Report of the Working Party on Noise on its seventieth session

Adopted amendments to UN Regulation No. 51 (based on ECE/TRANS/WP.29/GRBP/2019/13 and GRBP-70-26-Rev.1)

Annex 3 – Appendix, amend to read:

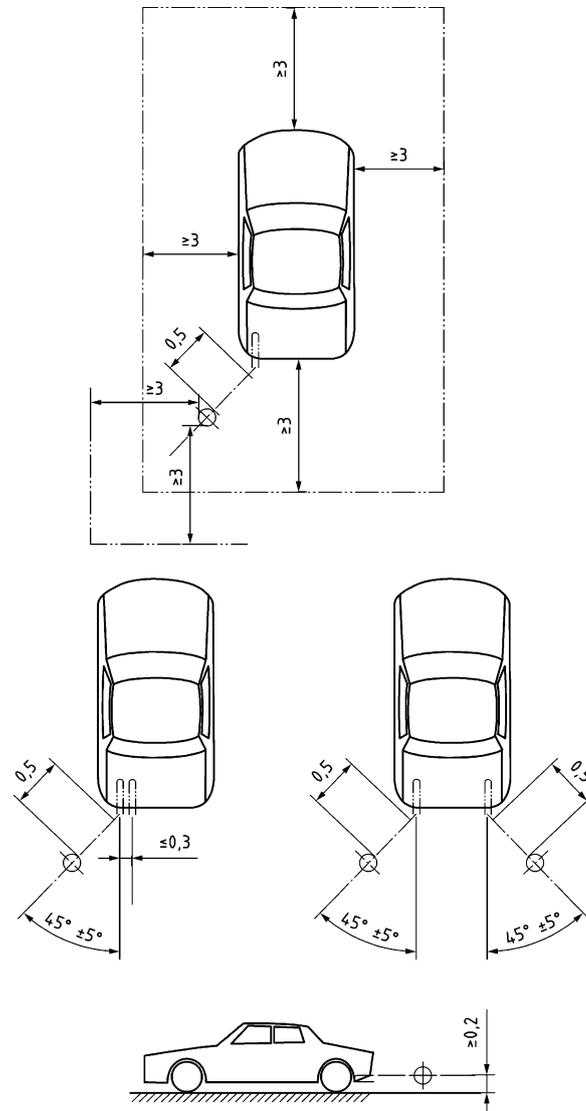
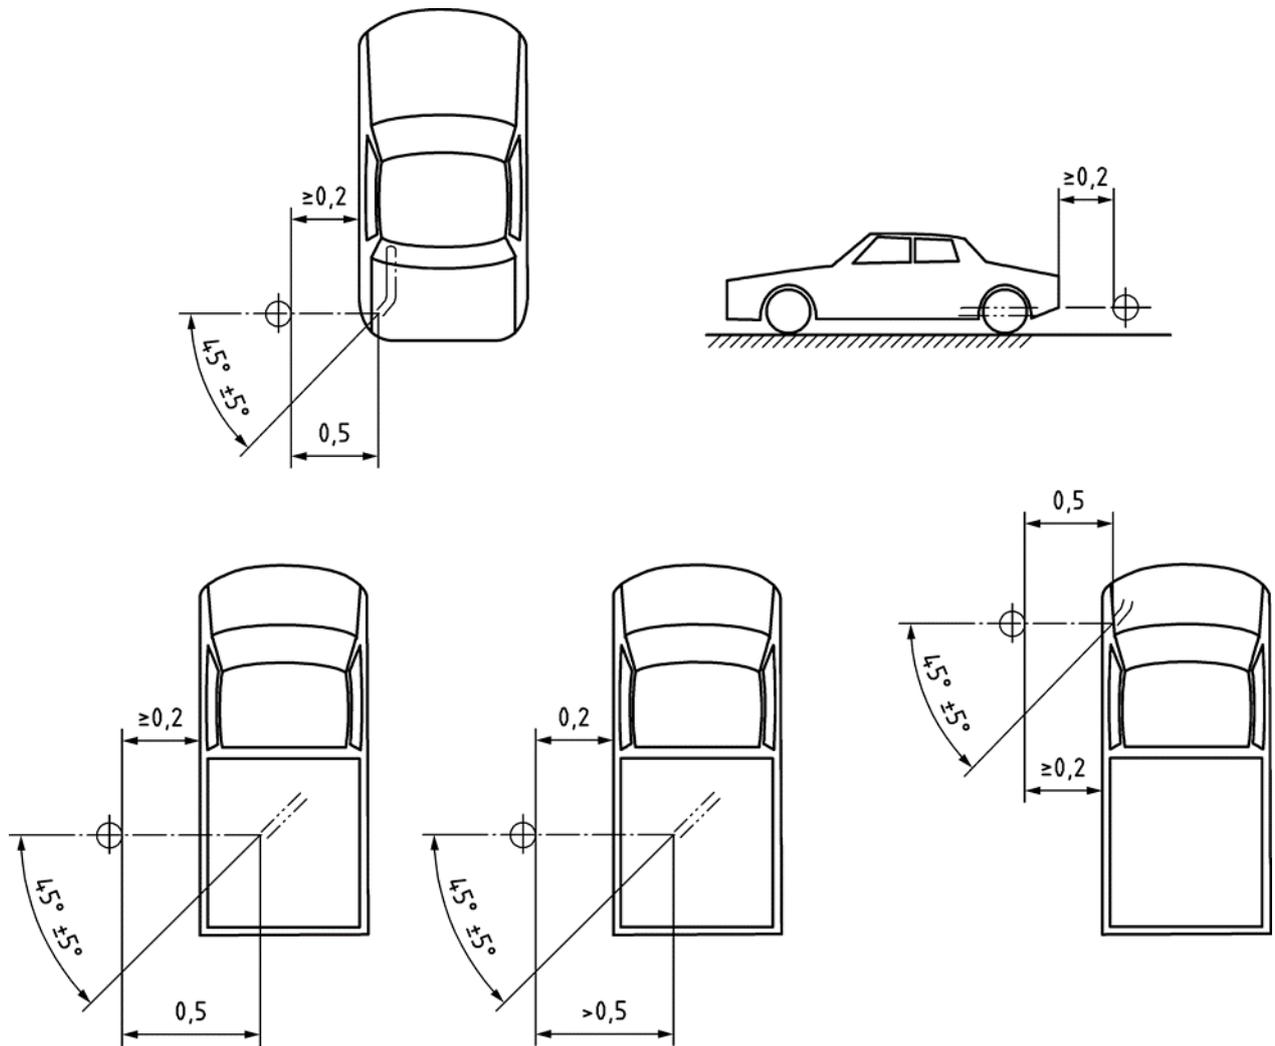
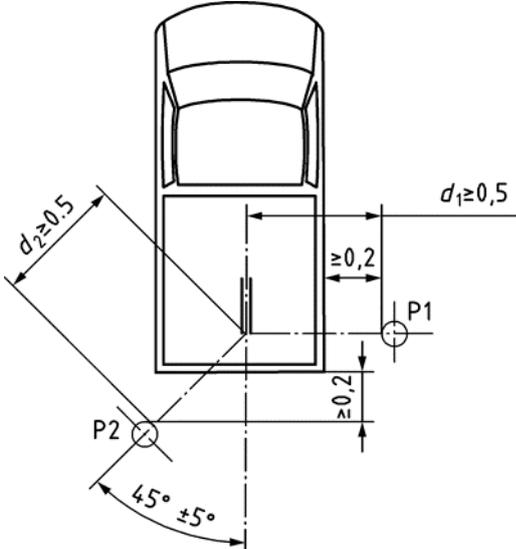
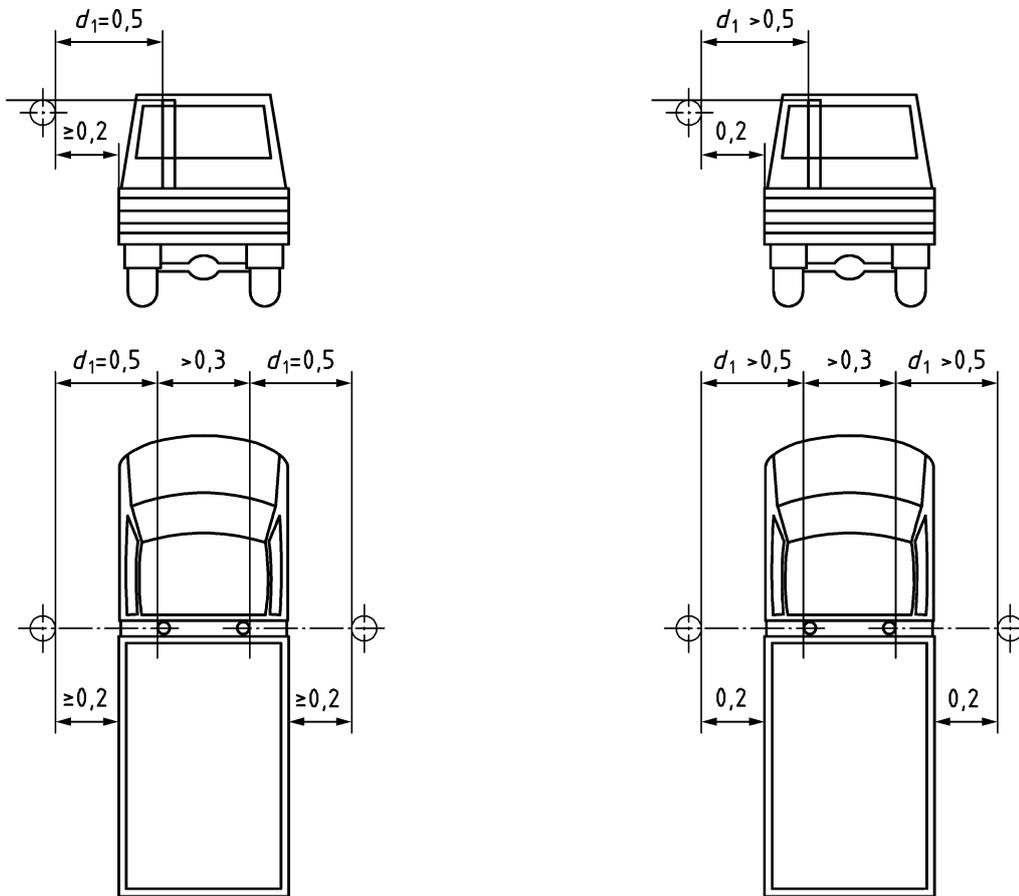
For vehicles, where the reference point of the exhaust pipe is not accessible, or located under the vehicle body, as shown in Figure 3b and 3c in Annex 3, because of the presence of obstacles which form part of the vehicle (e.g. spare wheel, fuel tank, battery compartment), the microphone shall be located at least 0.2 m from the nearest obstacle, including the vehicle body, and shall not be located under the vehicle. Its axis of maximum sensitivity shall face the exhaust outlet from the position least concealed by the above mentioned obstacles. In case the distance from the exhaust outlet to the other side of the vehicle is larger than 0.2 m (Figures 3c and 3d in Annex 3), the following distances of d_1 and d_2 shall be chosen:

When several positions are possible, as shown in Figure 3c, the microphone position giving the lowest value of d_1 or d_2 shall be used."

"Figure 4a

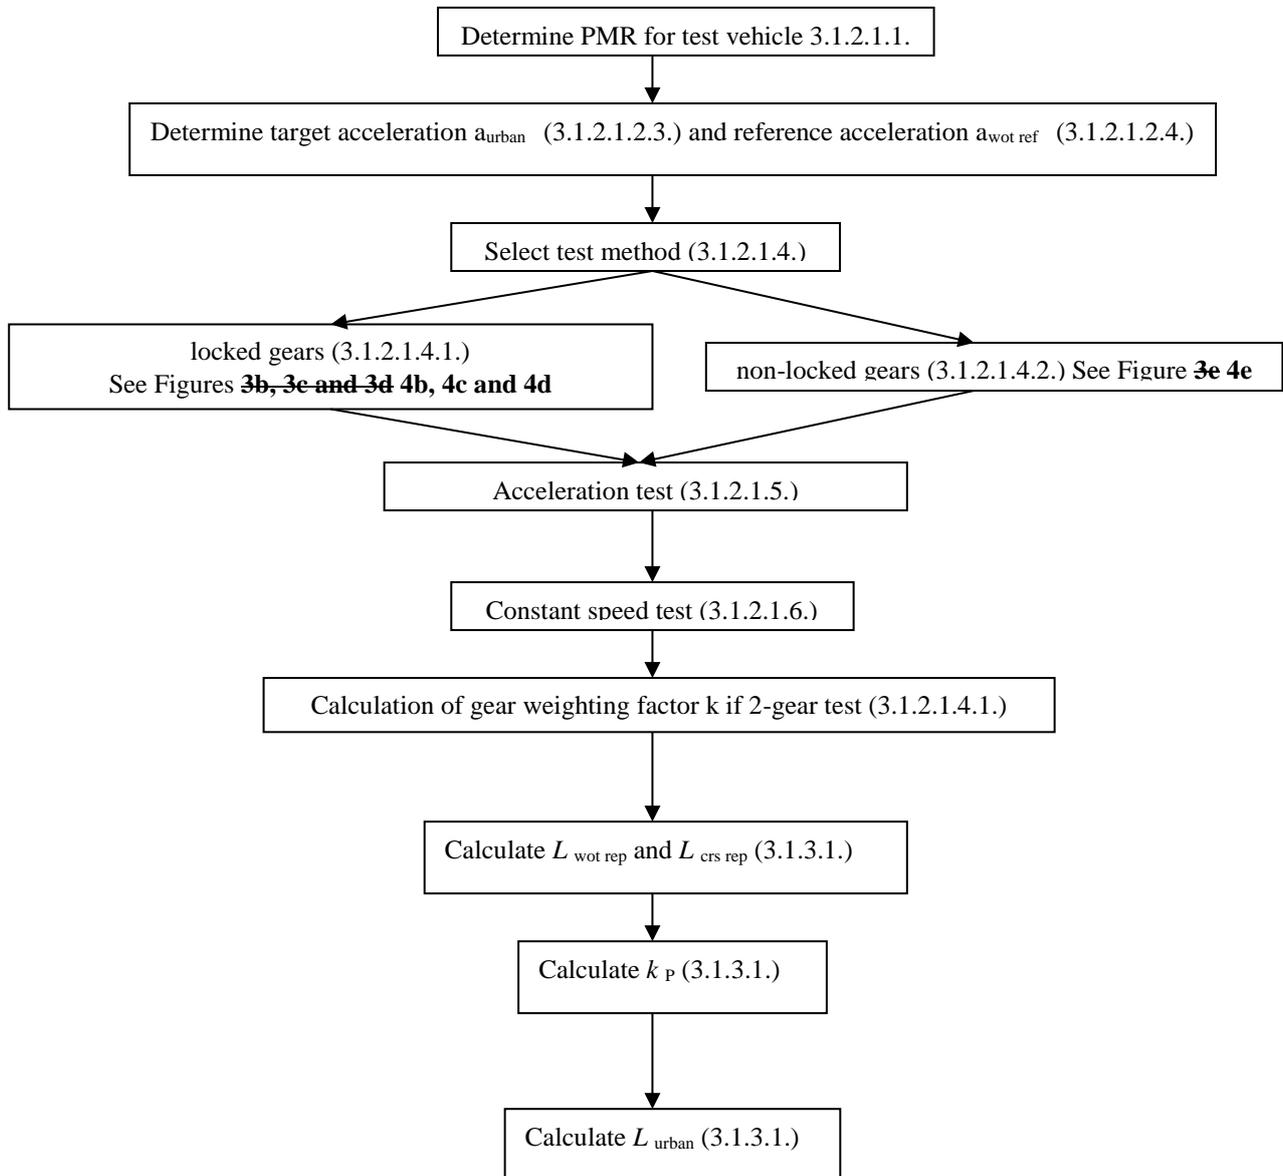
Figure 4a, amend to read

"Figure 4b

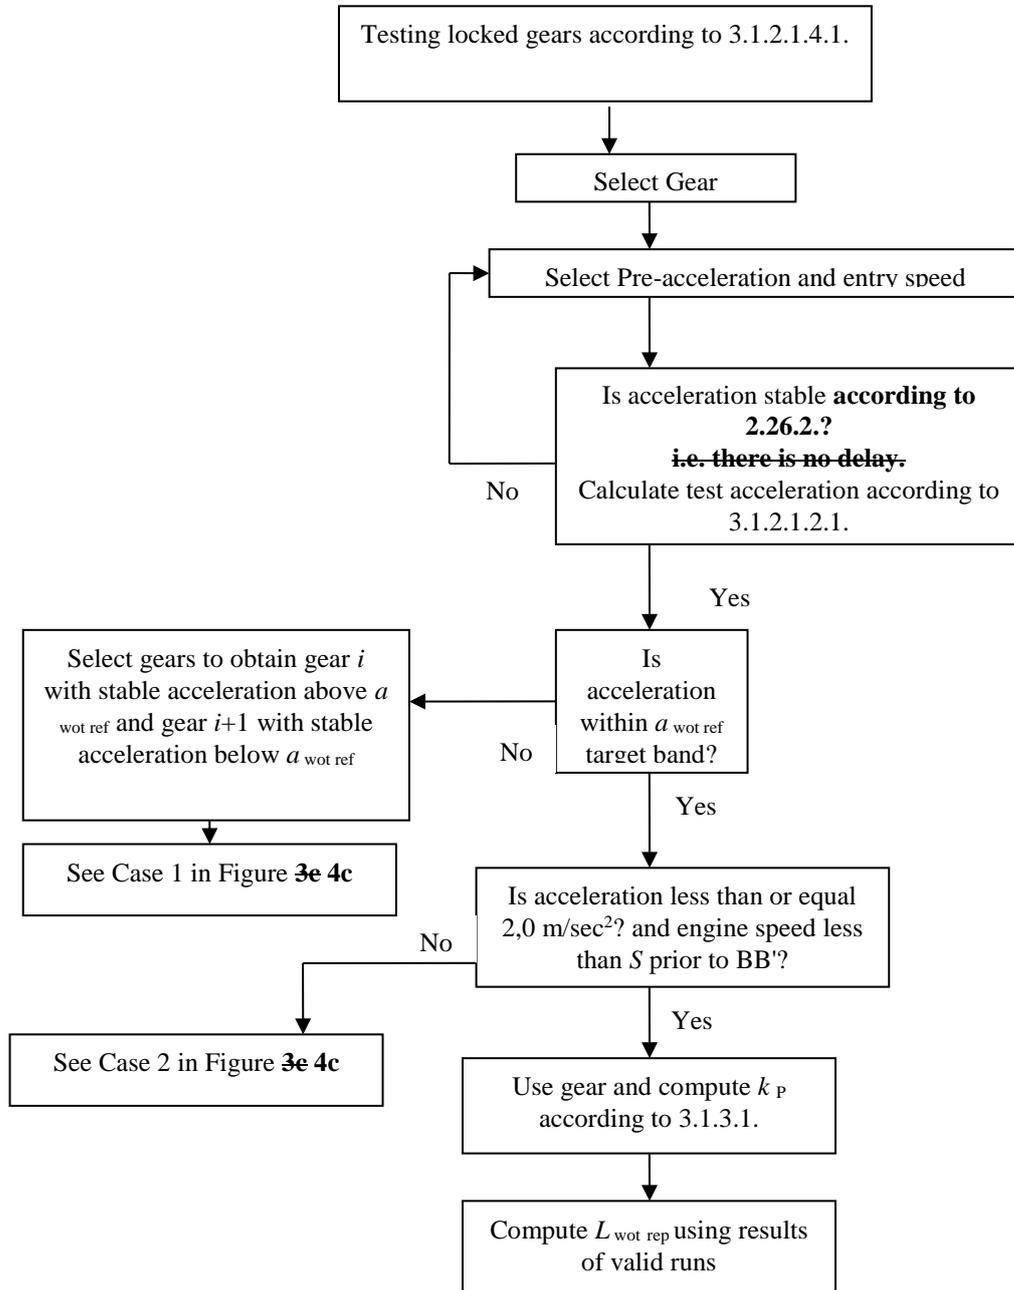
Figure 4b, amend to read:

"Figure 6
Flowchart for measurement and data processing of stationary sound according to
paragraph 3.2.

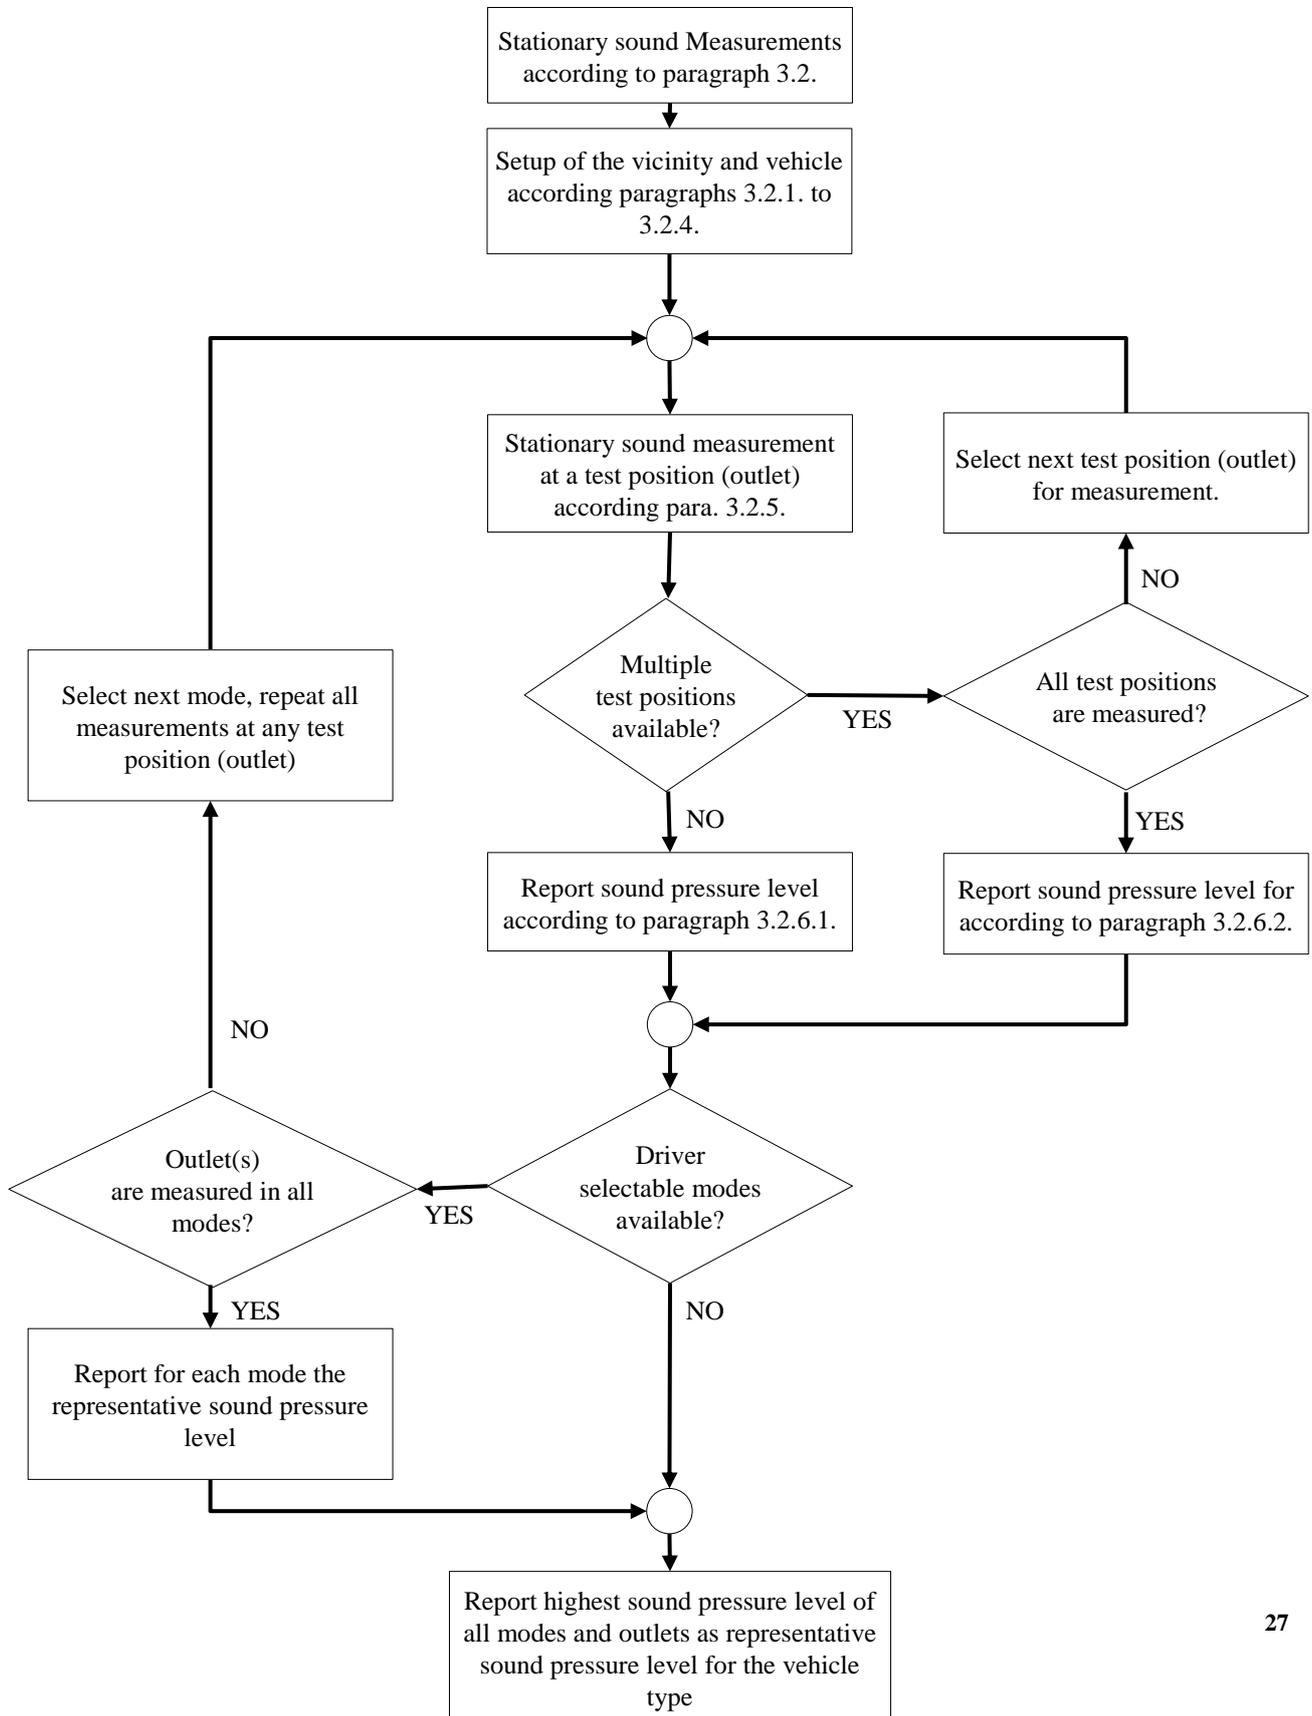
Add a new figure 6:
